Southern Regional Planning Panel Supplementary Report |

Panel Reference	PPSSTH-311
DA No.	DA-2023/849
LGA	Wollongong City
Proposal	Multi-dwelling housing development comprising 236 dwellings and associated earthworks, road construction and delivery, civil and landscaping works, community facilities (Stage 1) and use of up to five (5) dwellings for temporary exhibition homes
Property	Lot 197 Bong Bong Road Huntley
Applicant	Stockland Development Pty Ltd
Prior SRPP meeting	13 May 2025

Development Application DA-2023/849 was reported to the Southern Regional Planning Panel ('the Panel') on 13 May 2025. The Panel deferred the matter pending the submission of a supplementary report by Council. This supplementary report provides an overview of the information submitted by the applicant and Council's assessment to assist in the further consideration of the matters outlined in the Panel's Record of Deferral dated 21 May 2025.

BASIN RECONFIGURATION LAYOUT
SCALE 1:500

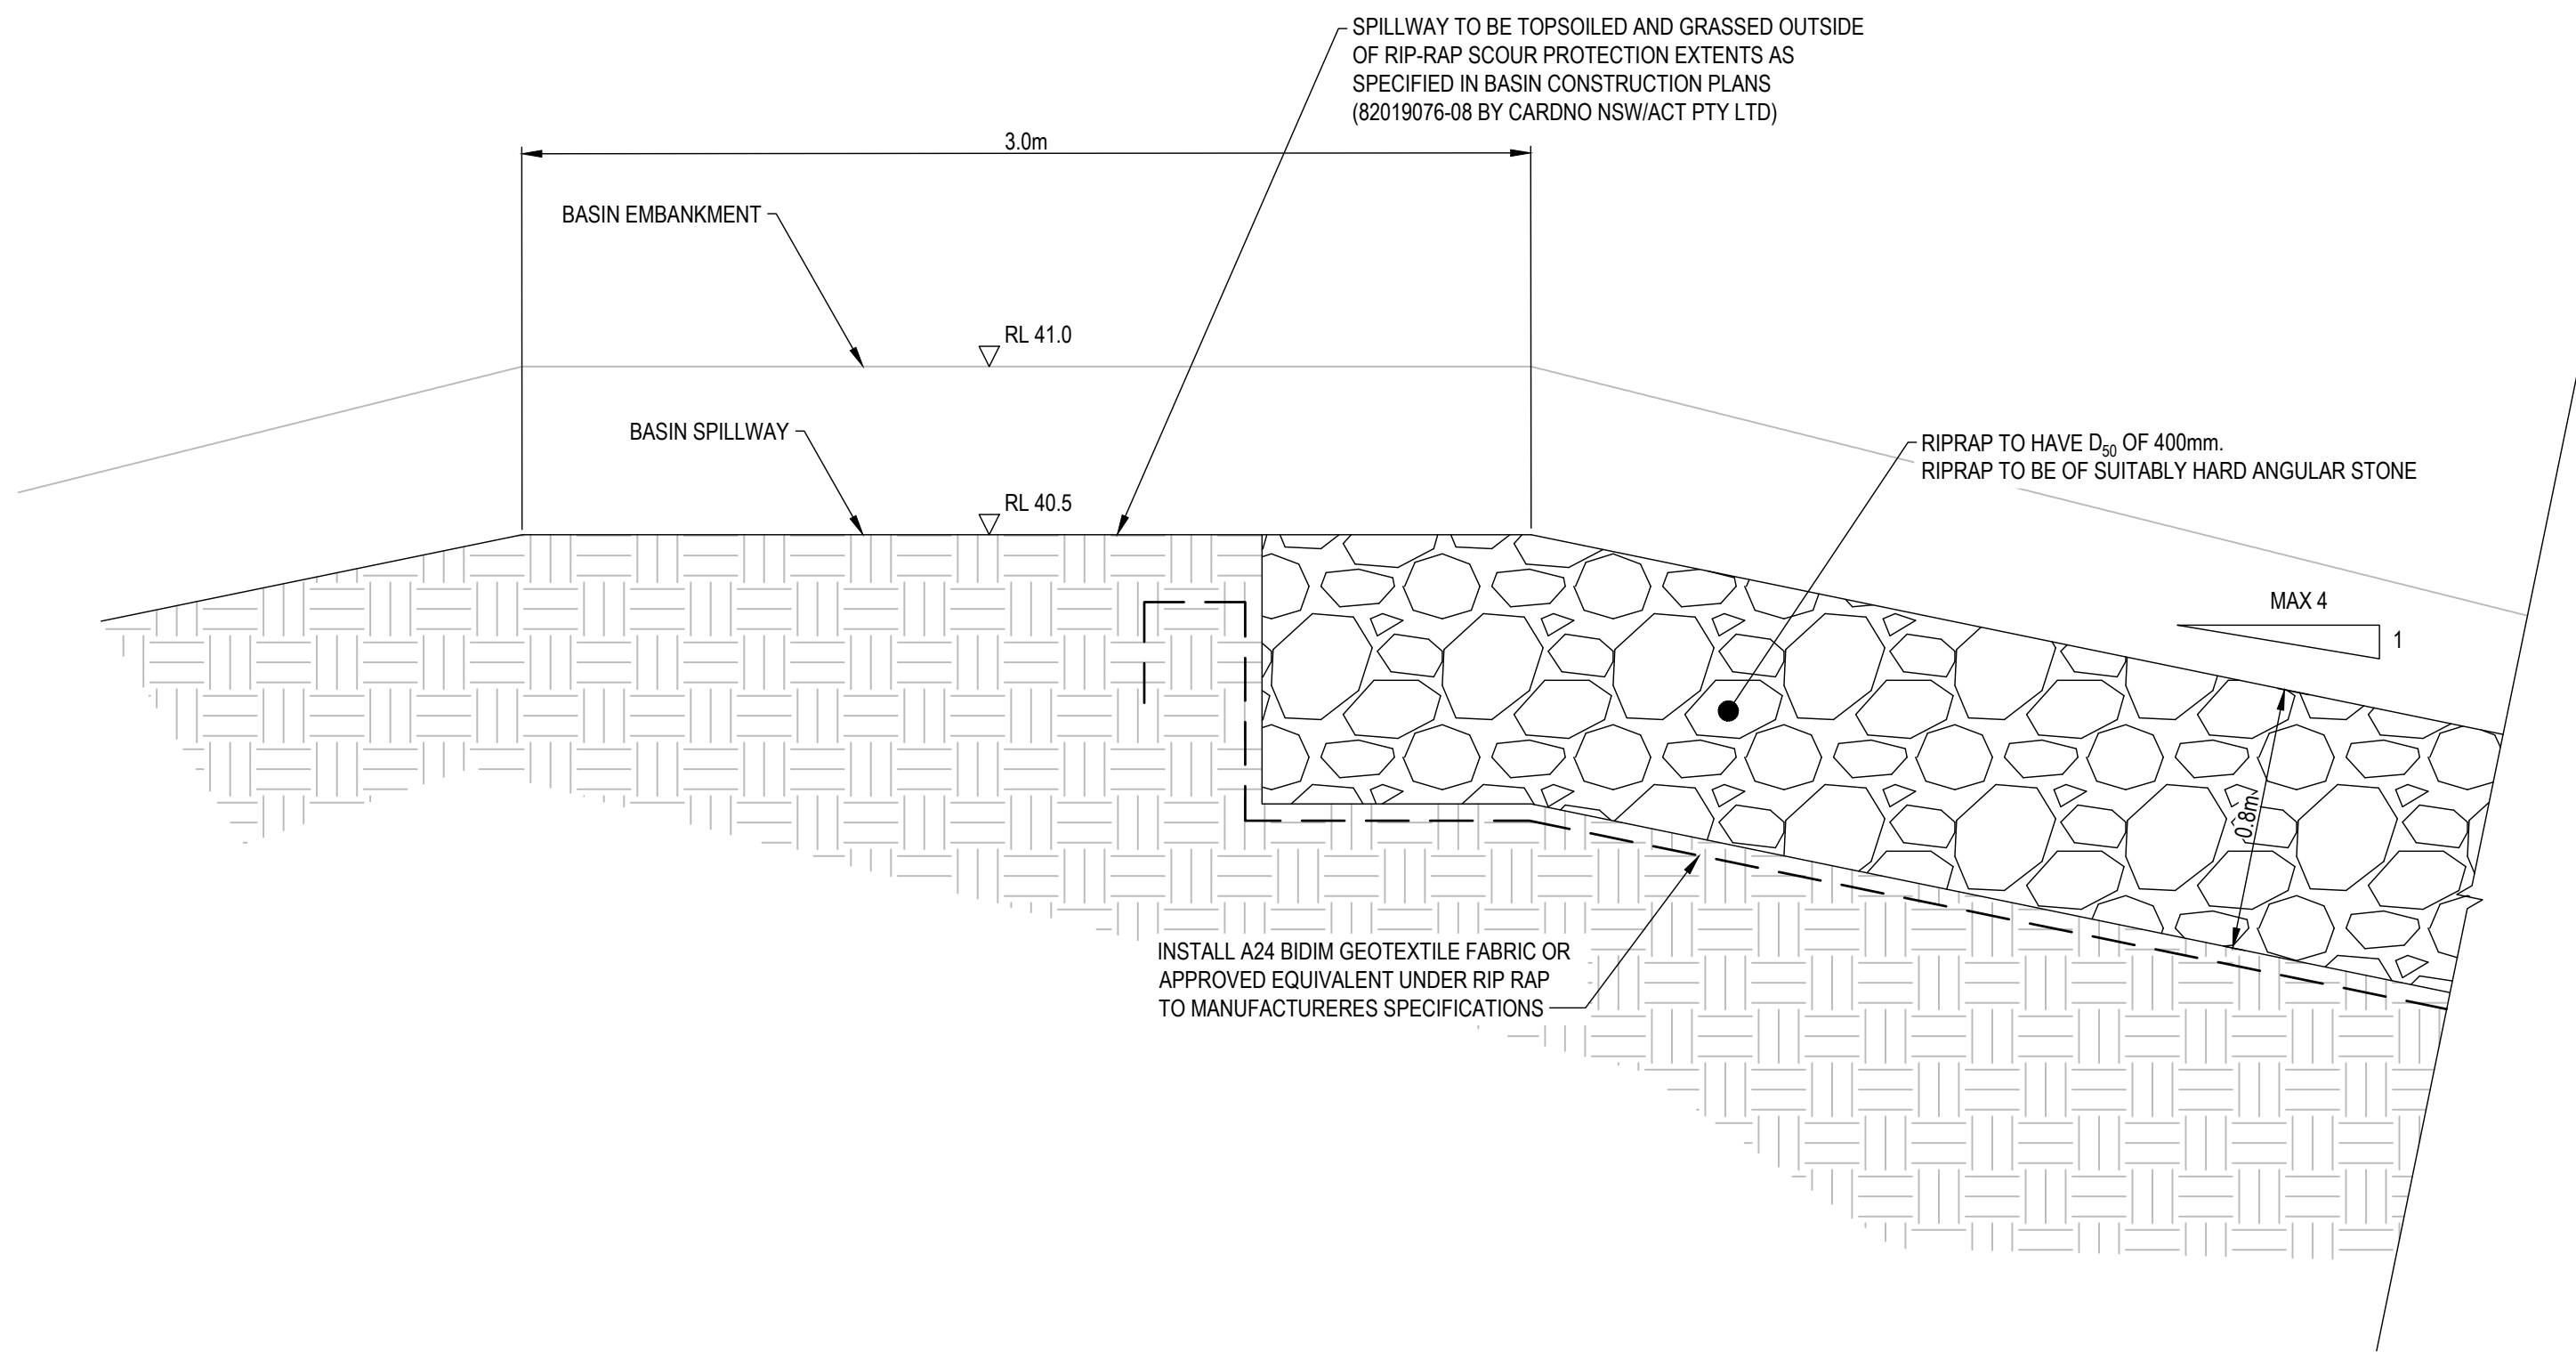
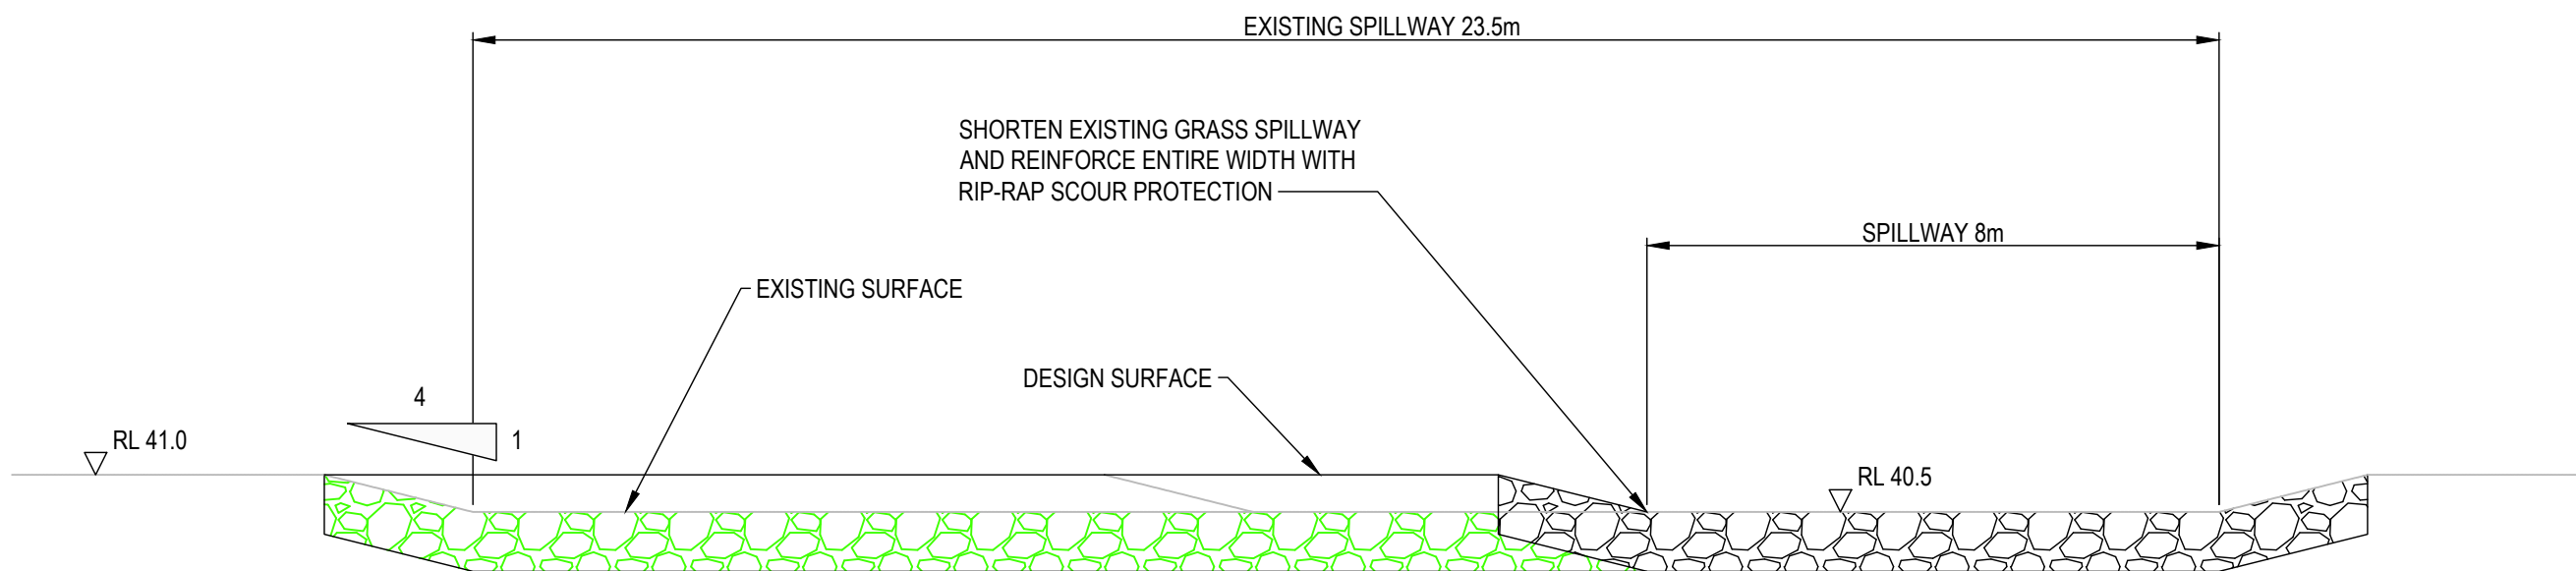
- *The plans showing the southeastern basin reconfiguration must be amended such that the proposed additional stormwater outlets are orientated in the direction of natural flow of the receiving watercourse channel.*
